# UNITED STATES PATENT AND TRADEMARK OFFICE

APPLICATION NO.	FILING DATE	FIRST NAMED INVENTOR	ATTORNEY DOCKET NO.	CONFIRMATION NO.
10/586,495	08/14/2006	Paolo Cerasoli	GRT/4865-90	4192

<b>Office Action Summary</b>	<b>Application No.</b> 10/586,495	<b>Applicant(s)</b> CERASOLI, PAOLO	
	<b>Examiner</b> QUYNH-NHU H. VU	<b>Art Unit</b> 3763

## **DETAILED ACTION**

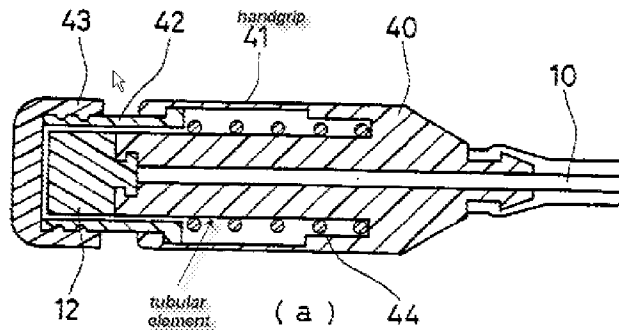
Diaz discloses a connector (catheter exchange syringe 10) comprising: a tubular element 12; a sleeve 22, 20 (Figs. 1-3); wherein the portion of 22 can be coupled to the connection or other device; the connector comprising: a spring 30 abutting between the sleeve and a charging handgrip 66 or 46 (Fig. 1).

It would have been obvious at the time the invention was made to a person having ordinary skill in the art to modify the device of Littmann in view of Diaz with a connector (as a syringe with spring), as taught by Diaz, in order to compress or place under tension to act as a source of potential energy for driving the syringe piston portion, while in the unloaded position, the syringe has released its potential energy and has driven the piston through the barrel.

As noted that, The combination between the device of Littmann and Diaz will bring the result such as: when the syringe of Diaz inserted into the connection at interconnection 28-31 (Fig. 1-4), 101, 102, 204 (Fig. 5) of Littmann, from there, the charging handgrip, the sleeve and spring of Diaz being arranged so as to bring the end portion of tubular element of Diaz closer to one of the receiving and releasing housings of Littmann by pushing element 52, then the spring 30 compressed (see Fig. 3 of Diaz).
